DESIGN REVIEW COMMISSION AGENDA

Tuesday, September 17, 2024 – 6:30 P.M.

1. Chipotle, 6600 Stage Road (Shawna Fuhrman, Dungan Design Group)

DESIGN REVIEW COMMISSION
Tuesday, September 17, 2024 – 6:30 P.M.
Bartlett City Hall Assembly Chamber
Staff Comments

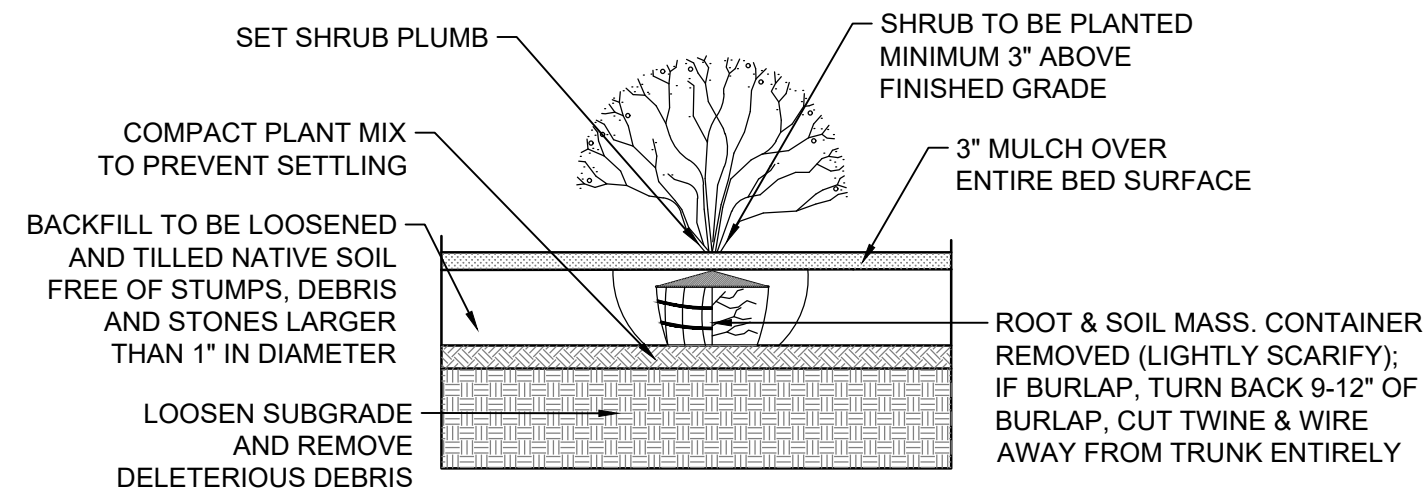
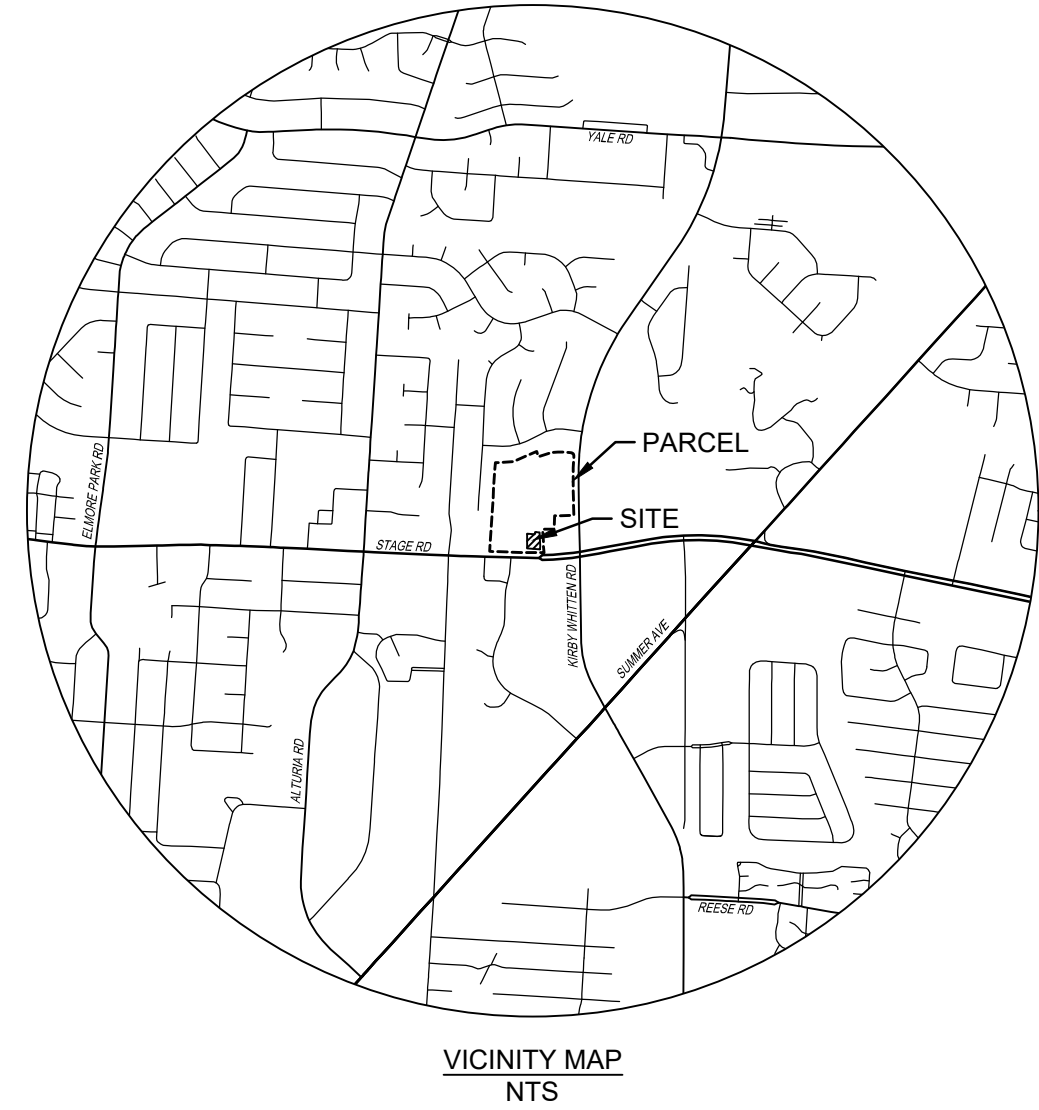
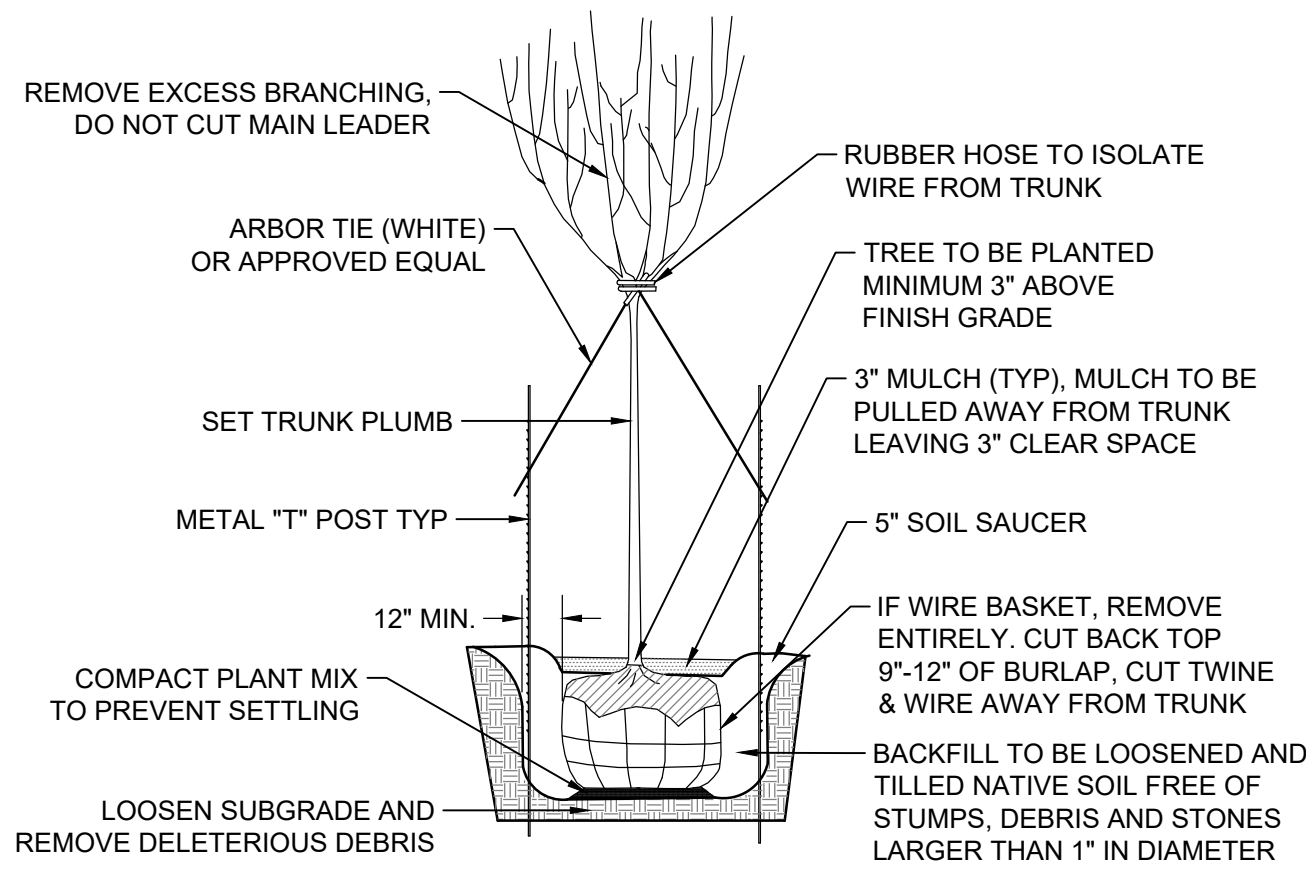
7. Staff recommends replacing the 2 "Overcup" Oak plantings with either Crape Myrtle, Chaste Tree, or Okame Cherry.
8. The applicant shall provide a tree protection plan showing which trees are to be removed and which trees are to be saved.

9. Applicant shall add Tree Density Unit Table to the landscape plan.
10. All proposed signage shall be submitted on a separate application to the Design Review Commission.

11. Irrigation is required for all planting on the landscape plan.
12. The commercial property owner will be responsible for landscape maintenance of the entire lot in perpetuity.
